City of Oregon City
South End Road Waterline Replacement
CI 15-012

ADDENDUM NO. 1
Issued: June 5, 2017

1. Sheet 10 (Drawing No. W08), Water Main Plan and Profile (STA 1+00B – 3+45B)

2. Sheet 11 (Drawing No. W09), Water Main Plan and Profile (STA 3+45B – 6+38B)

DRAWING NUMBER: **W09**
SHEET 11 OF 16

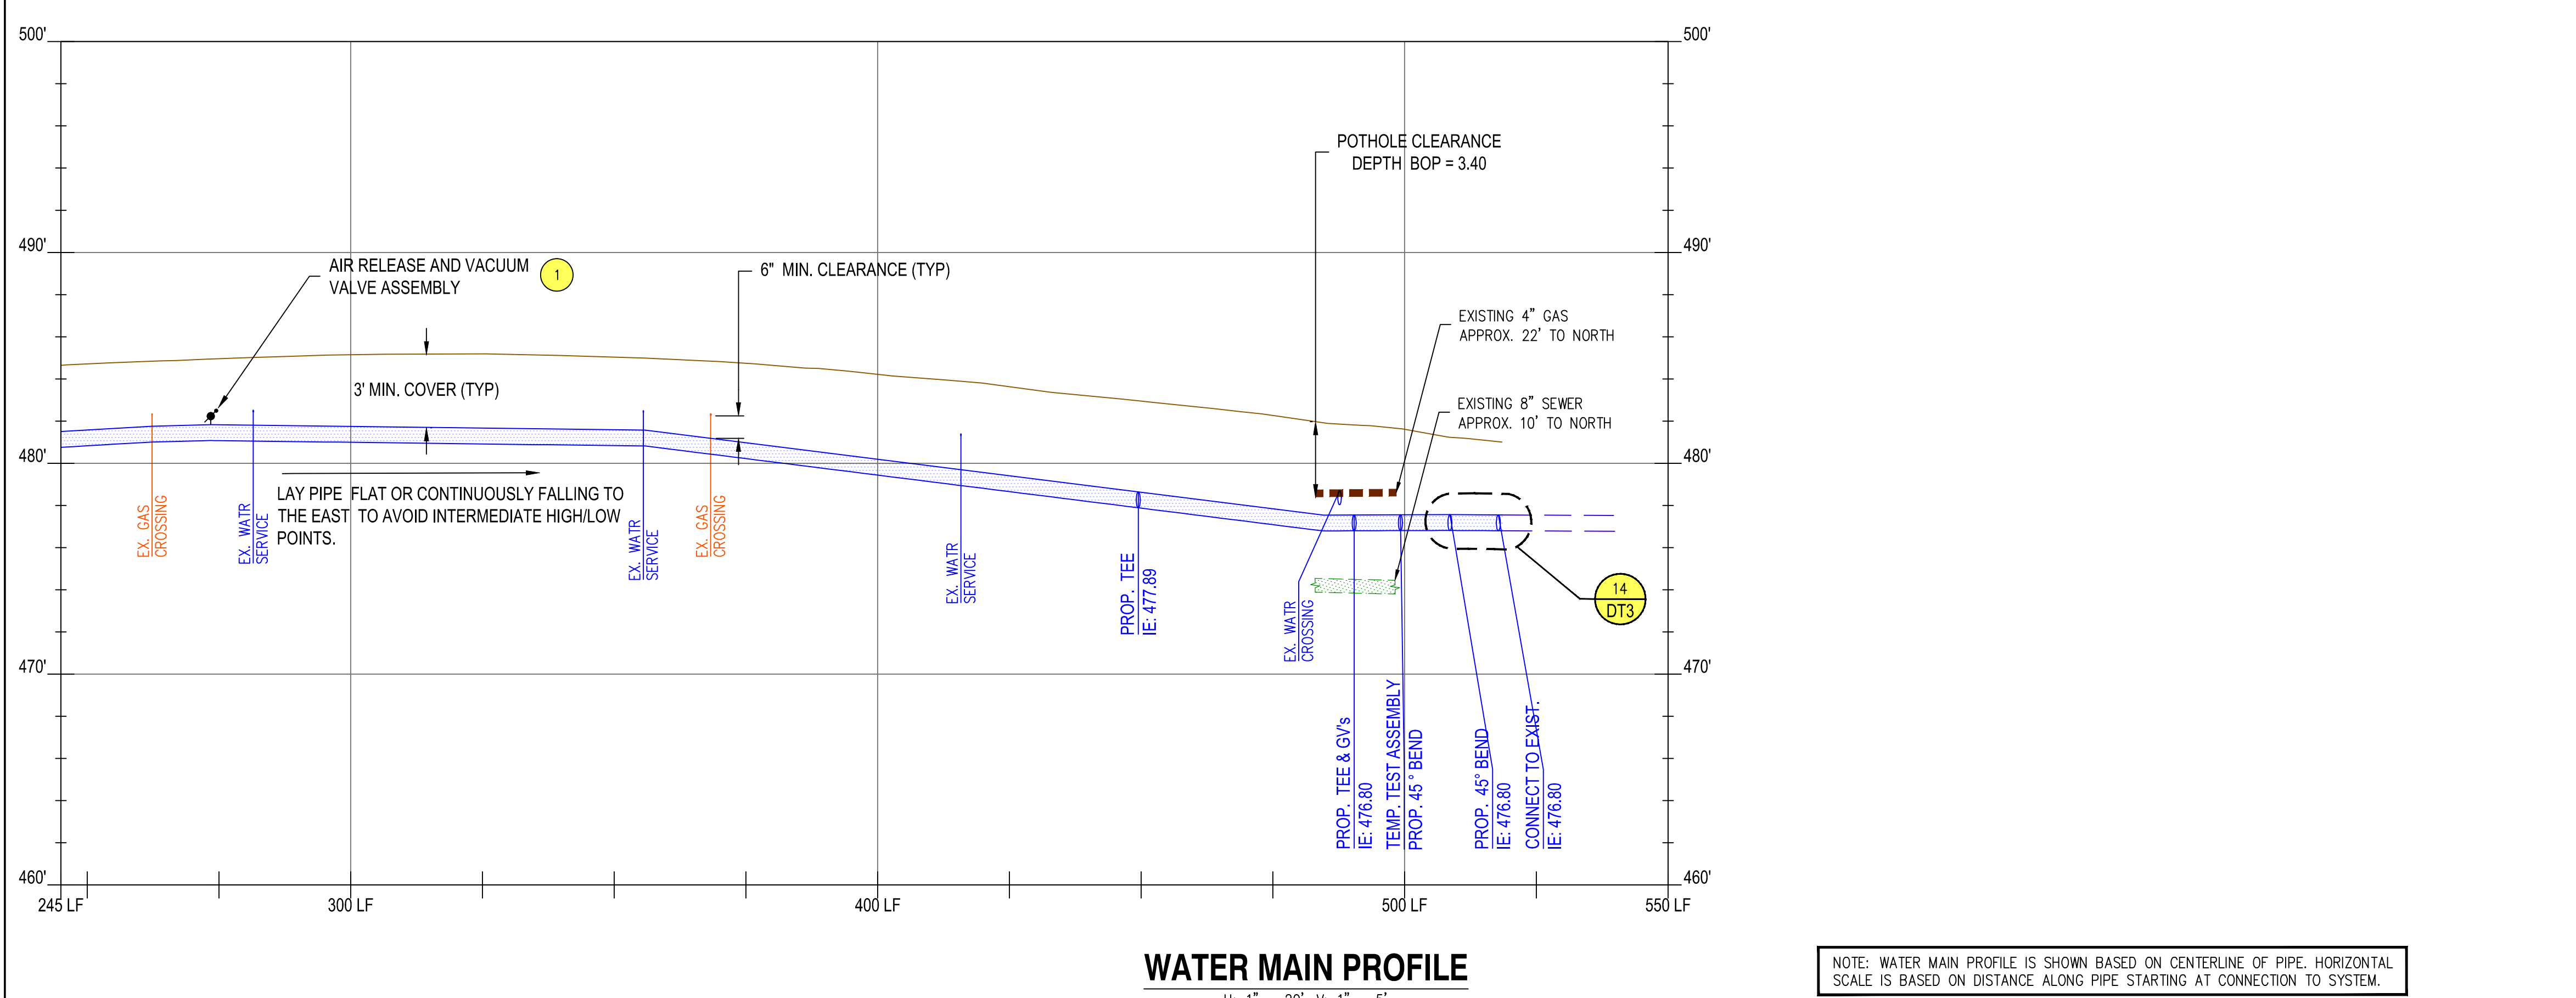
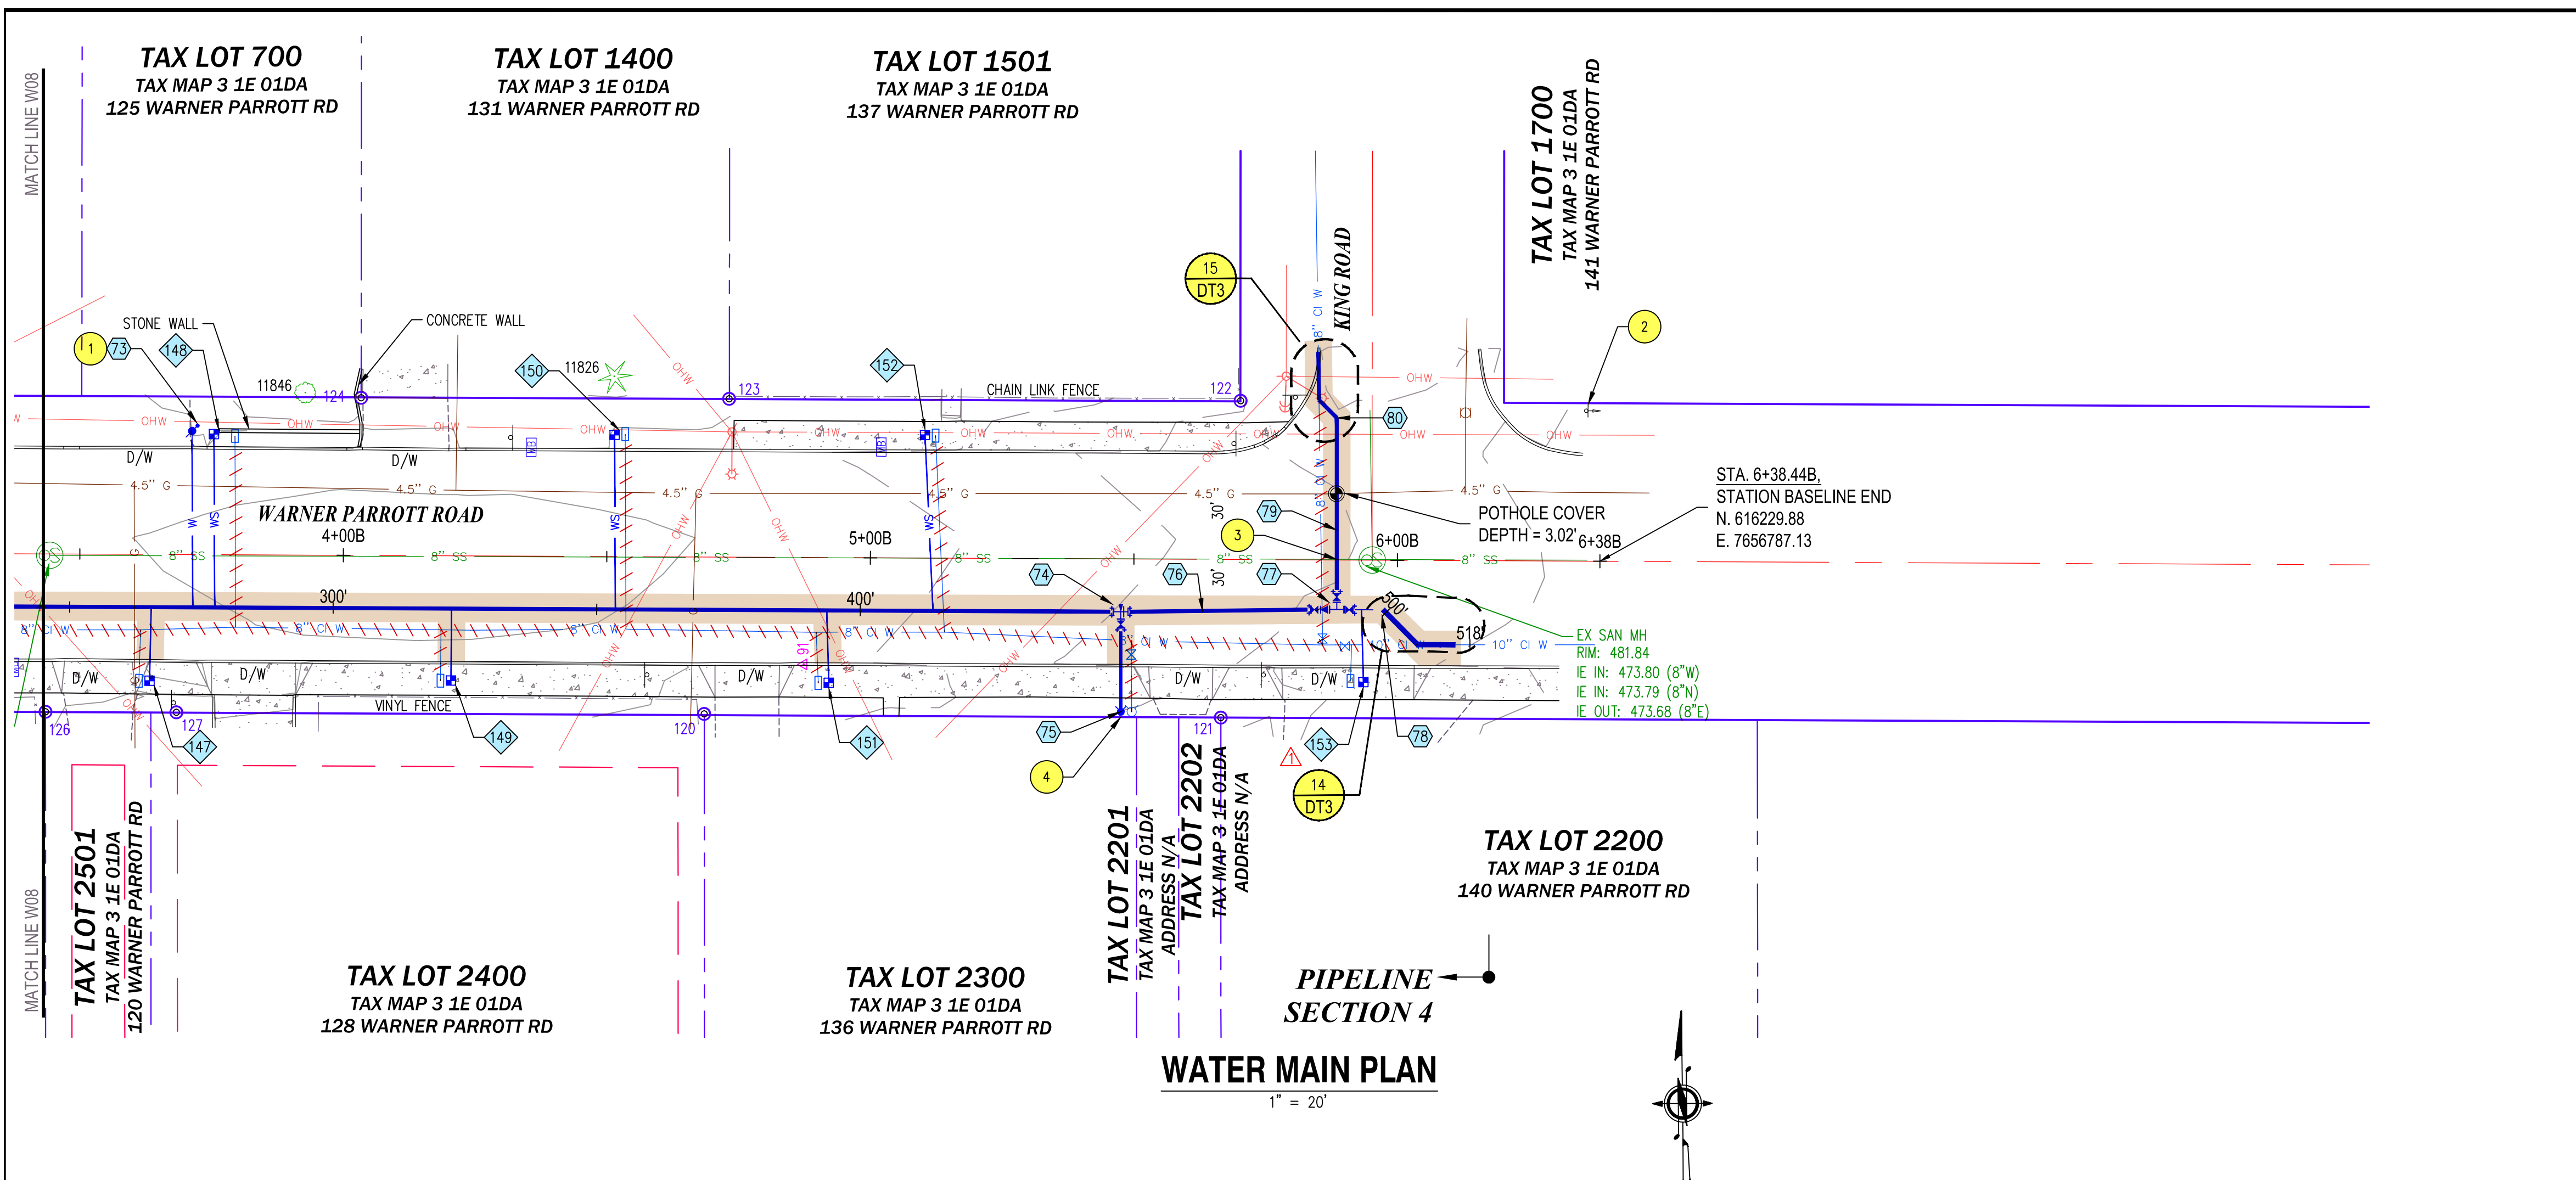
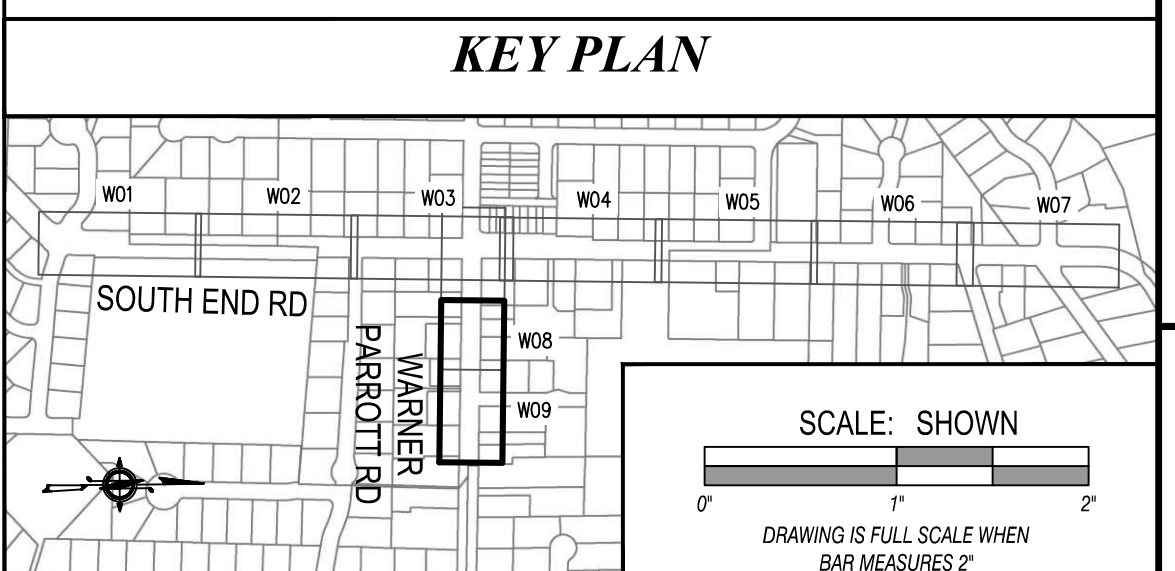
- (a) Replace Sheet 11 (Dwg No. W09) with the attached replacement sheet. The drawing has generally been revised as follows:
1. Added Water Service #153.
 2. Corrected station location callouts for water system fittings and services.
